Second Addendum to Final Independent External Peer Review Report Port Everglades Harbor Feasibility Study, Broward County, Florida

Prepared by
Battelle Memorial Institute

Prepared for
Department of the Army
U.S. Army Corps of Engineers
Deep Draft Navigation Planning Center of Expertise
Mobile District

December 1, 2014

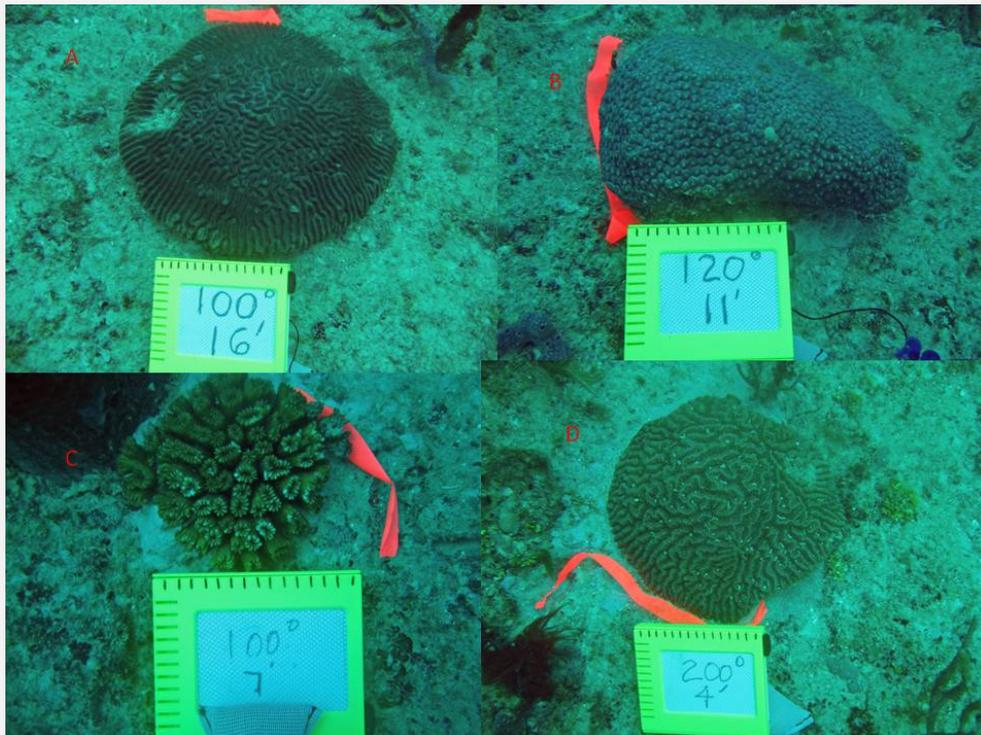
The recording of coral health observations in potential poor visibility and strong current conditions is not effective.

Attempting to record coral observations *in situ* could compromise the accuracy and efficiency of the data. “The position of each colony also will be mapped relative to the location of the net sediment accumulation block (distance and bearing) and recorded to allow relocation on subsequent surveys. Coral health assessment parameters will include bleaching, excess mucus production, polyp extension, and disease. Each selected coral colony will be assessed for each of the health parameters and assigned a health level of either "0" or "1" for each parameter. A score of "0" would indicate no observed bleaching, excess mucus production, polyp extension, or disease, while a "1" would be assigned for each parameter with a positive indication. The score for each parameter for each coral colony will be recorded, and the coral health observations” (Mitigation Plan, p. 3).

In situ written observations in currents and poor visibility are difficult to execute and not a good investment in time. An alternative is that each of the targeted corals should be photographed using a digital camera with at least a five mega pixel resolution (see image below from Team W, 2012).

The diver and assistant would use reference markers and show these data in the photo using an etch-sketch tablet to document important metadata (species ID, distance and bearing from reference). A compass and depth gauge can be attached to the tablet to provide those data in the coral photograph. The photos can be evaluated and scored for vitality (bleaching, disease infection, physical injuries, predation, growth, sediment issues, etc.).

1. Consider the use of reference markers and still photography in coral health observations.
